IEEE802.3bt
LLDP adhoc

Meeting #10: Tuesday September 4, 2017

- **The purpose** of this ad-hoc is to resolve LLDP state machine related comments from D2.4 and related issues for PSE and PDs prior sponsor ballot for D3.0.

Annex A: Why we need $Y=A+B$ as currently in the spec? -2

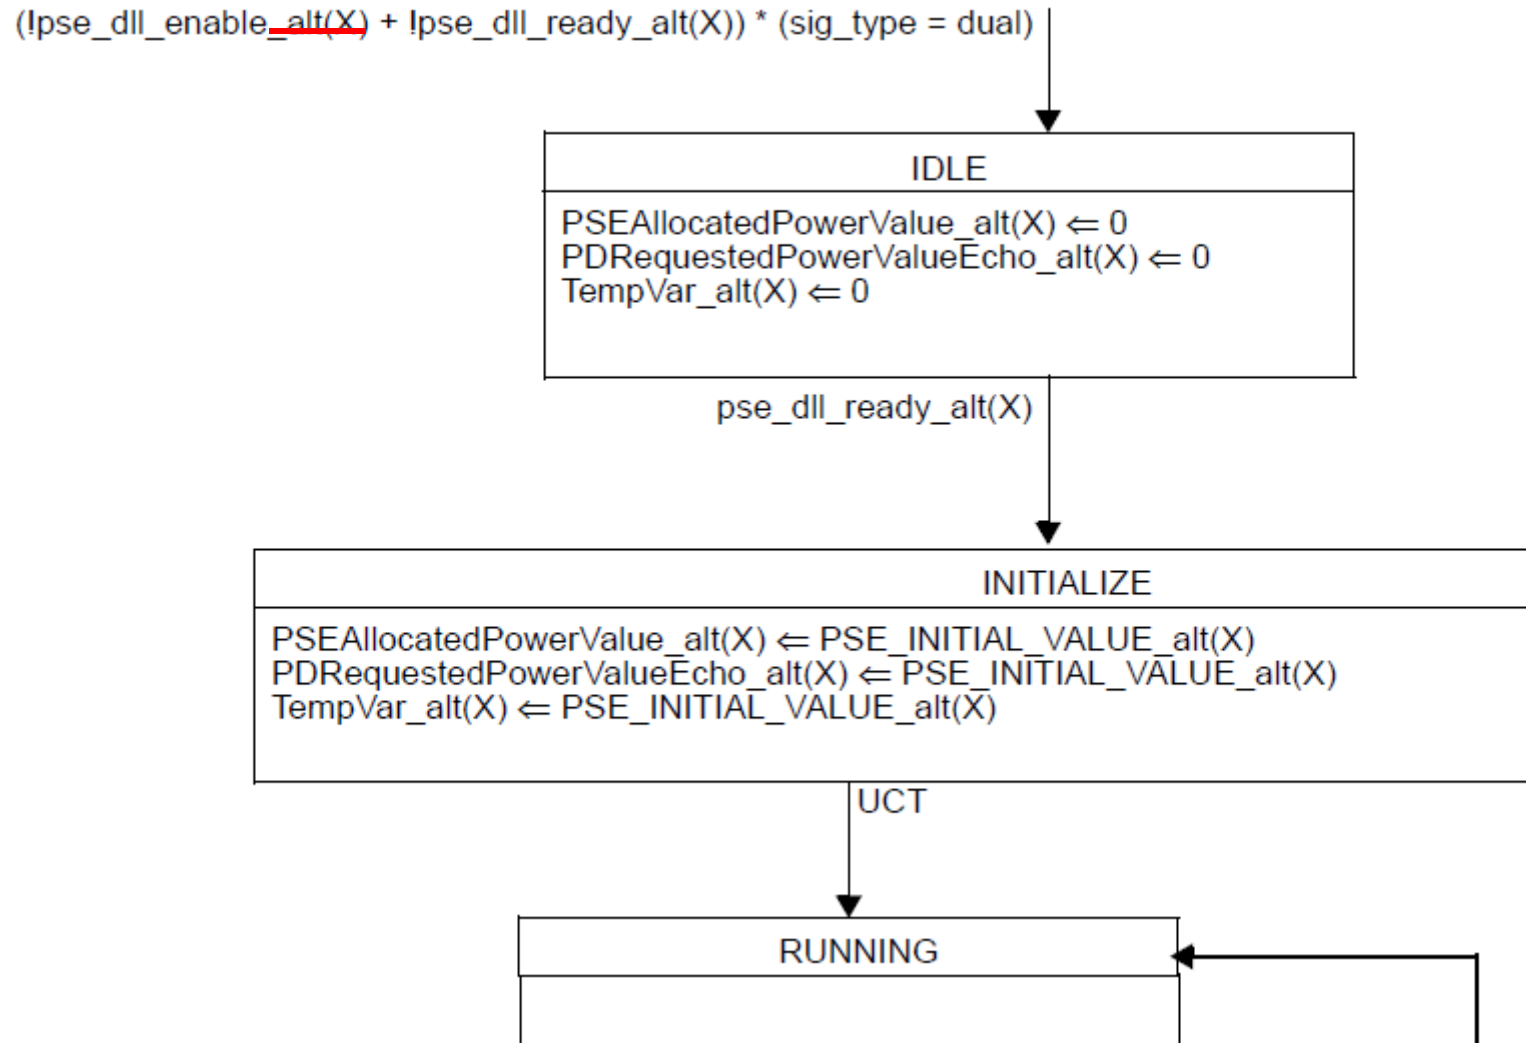
- Argument #3

High level power management care only for the total port power. The power management per pairset is kind of sublayer of the power management system. It is useful to pass the total power through the TLVs field. This is in general how current PSEs systems works.

Other alternative solution to this problem is to use the field “PSE max available power” which should be the total port power. We need to clarify in 79.3.2.6e that this value is applicable for PSE that supports single-signature and dual-signature.

Annex B: Comment #297 D2.4 (Page 75 line 12 in D2.5) - Figure 145-43 Meeting #8: Group is OK

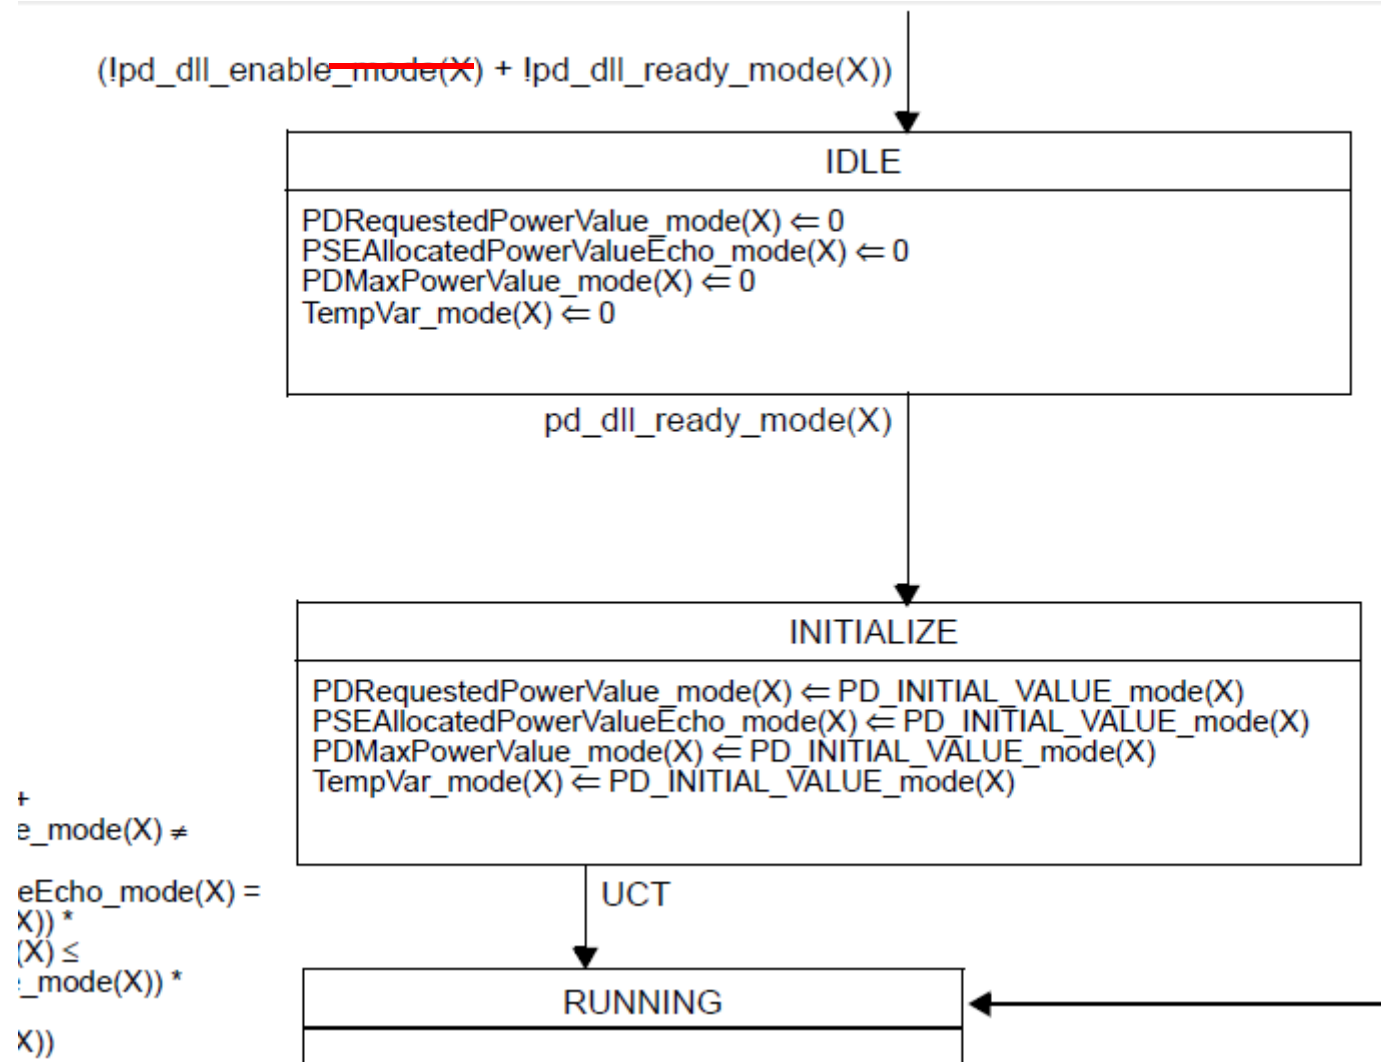
- Comment #297 D2.4 (D2.5 Page 78 line 46)

"If Mode (X) is non-active while the other mode is active, the inactive PD requested power value Mode (X) field value shall be set to 0."

- What is this trying to do ? The PD may wish to ask for power on an unpowered Mode...

Strike sentence.

- In Figure 145-44 and Figure 145-45 power control state diagrams when connected to dual-signature PD, we add in D2.3 an IDLE state in order to resolve non active Alternative(X) or no active mode(X) by setting the relevant variables to zero prior going to INITIALIZE state.
 - Figure 145-45: PSEAllocatedPowerValue_alt(X), PDRequestedPowerValueEcho_alt(X) and TempVar_alt(X)
 - Figure 145-46: PDRequestedPowerValue_mode(X), PSEAllocatedPowerValueEcho_mode(X), PDMaxPowerValue_mode(X) and TempVar_mode(X)

- Yair it will work:
- The proposal is:
 - To change from `pd_dll_ready_mode(X)` to `pd_dll_ready` in the PD state machine.
 - To change “if this mode/Alt is inactive, set to value 0” to “if this Alt is inactive, set to value 0” i.e. keep this requirement only to PSE.

- Lennart response: The proposed response to this comment is to adopt:
 - To change from pd_dll_ready_mode(X) to pd_dll_ready in the PD state machine.
 - To change “if this mode/Alt is inactive, set to value 0” to “if this Alt is inactive, set to value 0” i.e. keep this requirement only to PSE.
- **Group to discuss.**
- **GROUP OPINION? Group is OK.**
 - The modifications proposed to the state machine in Figure 145-43?
 - To change from pd_dll_ready_mode(X) to pd_dll_ready in the PD state machine.
 - To change “if this mode/Alt is inactive, set to value 0” to “if this Alt is inactive, set to value 0” i.e. keep this requirement only to PSE.

Annex I: Meeting #5: Comment #130, #293 D2.4 (D2.5 Page 74 line 11)

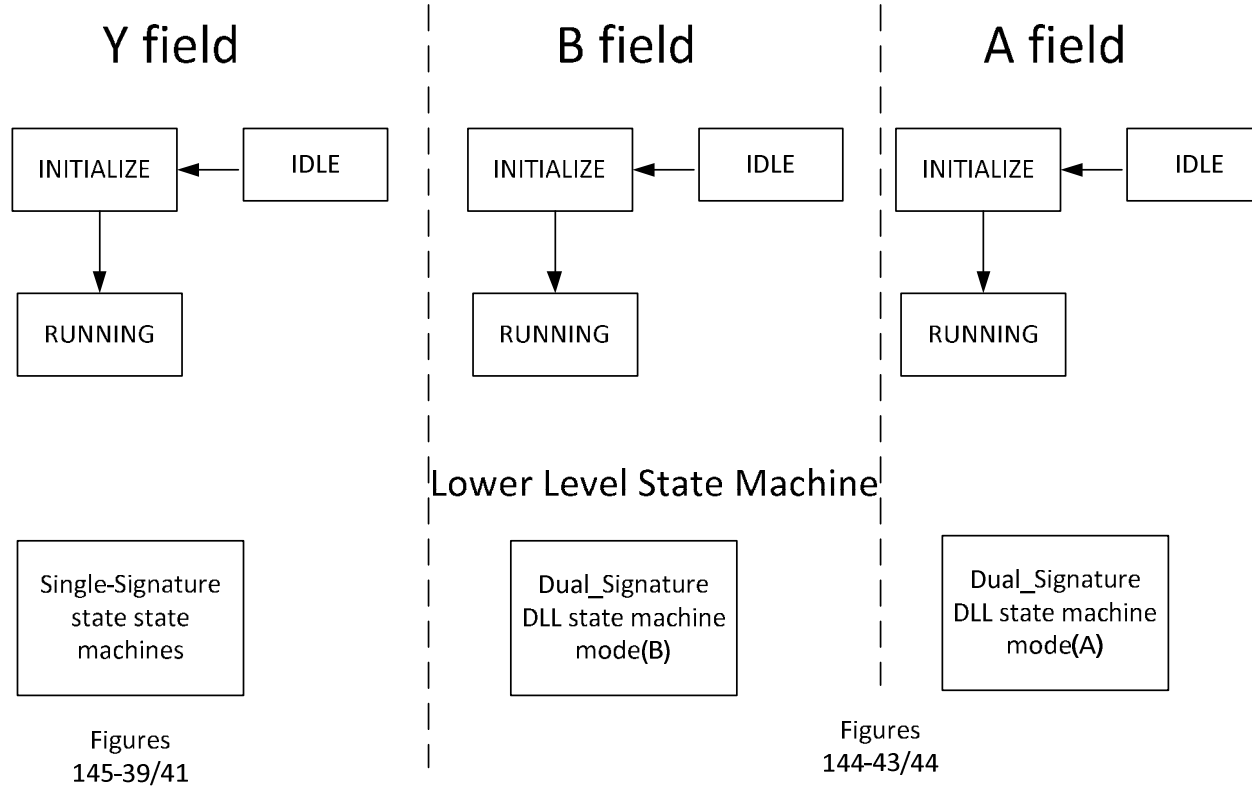
Added text, "Type 1 and Type 2 devices shall not support the Type 3 and Type 4 extension."
Incorrectly blocks legacy types from using TLVs, Power status, System setup, PSE maximum available power, Autoclass, and Power done. The existing text does indicate what legacy Types are required to place in all Type 3 and Type 4 extension fields.

- **David Stover/Heath** : To move 4PID field to the legacy TLVs and not allow Type 1 and 2 devices to use the new TLVs.

Lennart: Implemented in the baseline.

Group Agrees: YES (and change the "shall" to "out of scope")
